Subject: Duke Energy Carolinas, LLC (Duke)
McGuire Nuclear Station, Units 1 and 2
Docket Nos. 50-369 and 50-370

Application to Revise Technical Specifications Regarding Control
Room Envelope Habitability in Accordance With TSTF-448,
Revision 3, Using the Consolidated Line Item Improvement Process

Re-transmittal of License Amendment Request (LAR) dated
January 22, 2008

SR 3.7.9.3

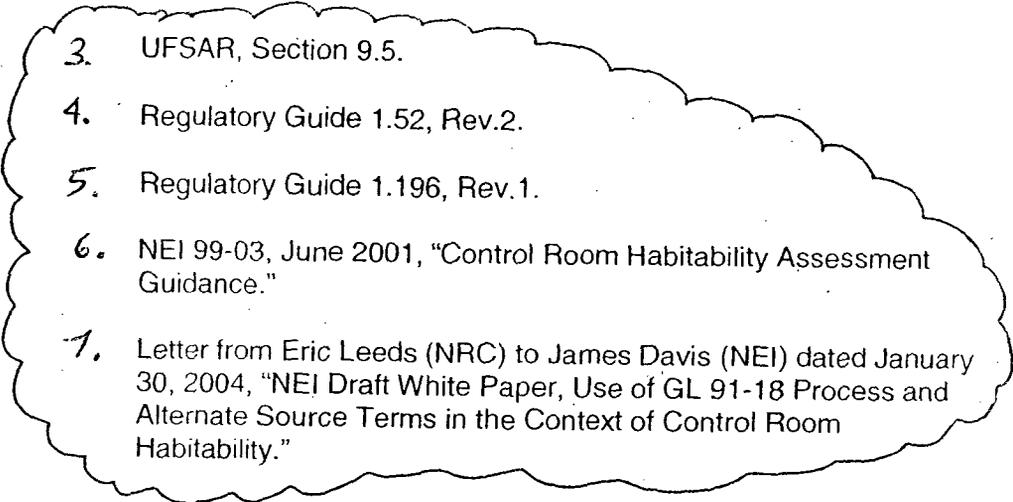
This SR verifies that each CRAVS train starts and operates with flow through the HEPA filters and charcoal adsorbers on an actual or simulated actuation signal. The Frequency of 18 months is specified in Regulatory Guide 1.52 (Ref. 4) based on industry operating experience.
